Reviewer 1 answers:

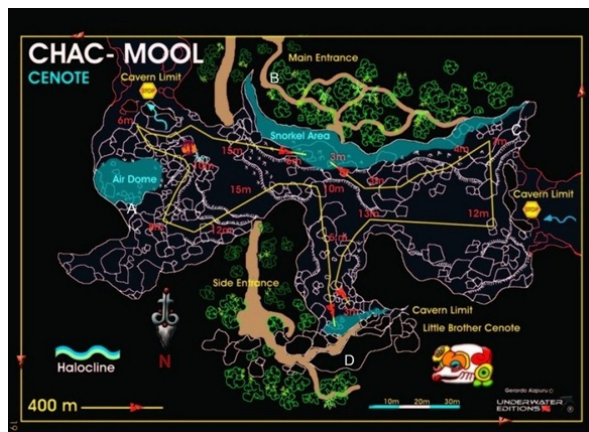
To improve manuscript. Authors indicate that there are previous works in the area carried out by the Speleological Survey; It should be interesting to be able to compare the obtained data from geophysics and the available data from direct study.

We added some lines in the manuscript saying that The (x, y) locations was obtained from the scuba divers map. The depth (z) is inferred from our 3D resistivity model. We sign the inferred cave section as a rectangle, because we cannot see details. Where dot is red is because is not reported by the scuba divers map, but we see a similar pattern where a river crosses. This location is inferred.

The scuba diver map is for tourists and it was difficult to extract the information we needed, as you can see.

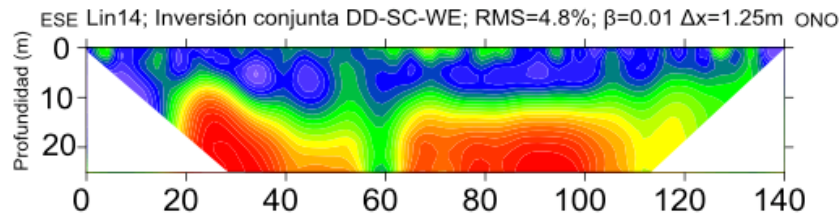
There are not units in the representation from figure 4 (color scale), at figure 5 the scale color requires an inset ($\log_{10}(r)$ means, r at logarithmic scale but it lacks units and the figure caption requires to be rewritten as I am not sure that I am able to understand what is described.

We corrected this, putting units on the plots.
